Our Ref: Lt_633.10057_RTS_Mar2013(Final)

**RESPONSE TO SUBMISSIONS:
PROPOSED MODIFICATION TO BLAKEFIELD NORTH UNDERGROUND MINE
DA 376-8-2003 (MOD 5)**

Table 1 - Response to Submissions: Modification to Bulga Underground Mine (DA 376-8-2005 Mod.5)

Figure 1 – Assessed Drilling Locations

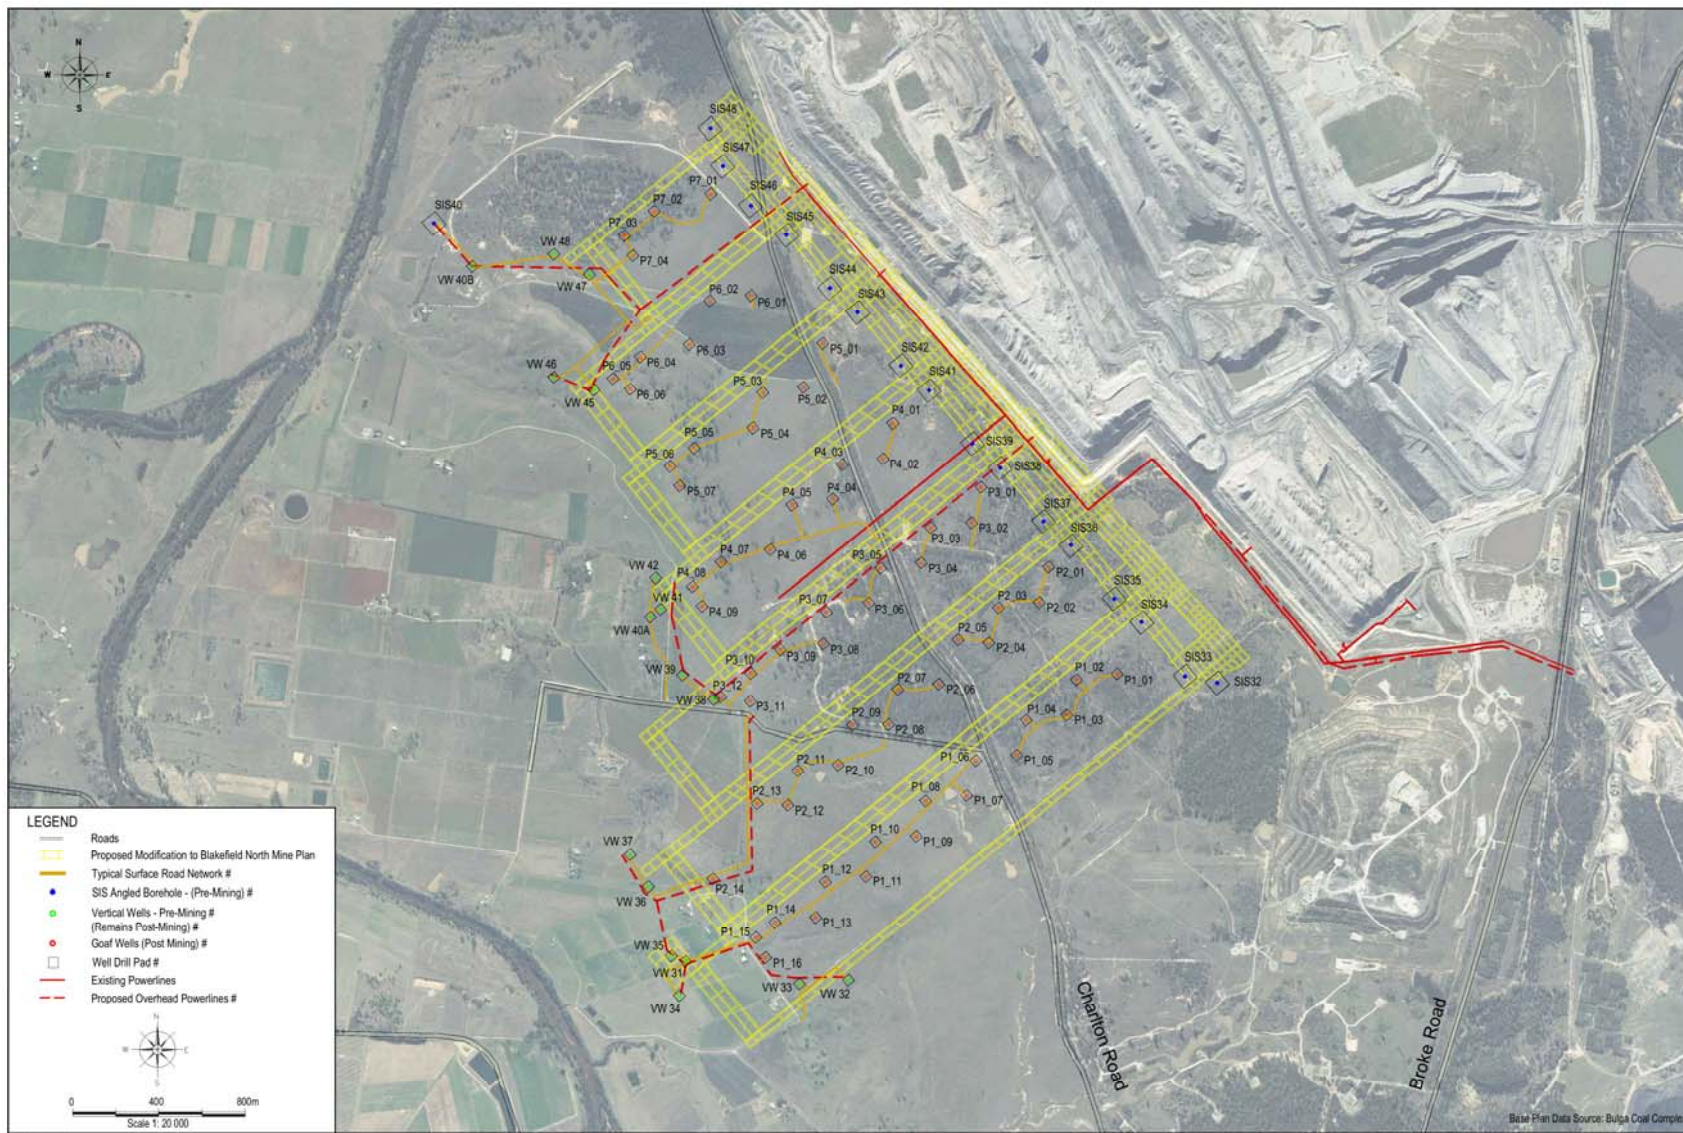
5.6	Noise Assessment (Item 3) The EPA is concerned that the choice of two "worst case" vertical well drilling locations appears to have underestimated the noise impact of this activity on sensitive receivers, and that therefore more receivers may be	A revised NIA that considers all proposed drilling locations is included as Appendix 2. The drill locations for which results are provided in the EA are worst case for the evening and night periods (they are the only substantial construction activity planned for those times).

Ref.	Matters Raised in Submission	Response
	significantly affected than those indicated in the EA. With reference to Figure 8 of the EA, it appears that a number of sensitive receivers will be in close proximity to vertical well and goaf well drilling operations and experience noise impacts of greater than 5 dBA above the PSNL at various stages throughout the life of the project (20 years), as the actual drilling locations are proposed to be distributed across each longwall. The EPA therefore does not expect to be able to licence noise impacts at these receptors and recommends the proponent pursue a private negotiated agreement at the following sensitive receivers: 160 Dwyer, 217A, 217B and 217C Russell, 156A and 156B Todhunter & Brook, 179 Brooks & Thompson, 162 Lamaro, 164 Sharrock, 195 Kennedy, 154 Rath, 169B McCraw, 171 Owens, 151 (Unknown) and 197 (Unknown).	The results of the revised assessment indicate the following receptors would experience levels exceeding the DP&I agreed day period construction noise criterion of LAeq,15 minute 45 dB: 160 Dwyer, 195 Kennedy, 217n, 217m and 217s Russell, and 165B Todhunter and Brook. BCM will negotiate a private agreement with these receptors. For more detail on revised construction noise results, refer to Appendix 2.

To address this concern, additional assessment has been undertaken that considered all proposed drilling locations (surface to in-seam (SIS), vertical wells, and GOAF wells). Figure 1 illustrates the locations of all assessed drill locations. Model inputs (topography, receptors, prevailing meteorological conditions, and sound power) are as presented in the NIA.
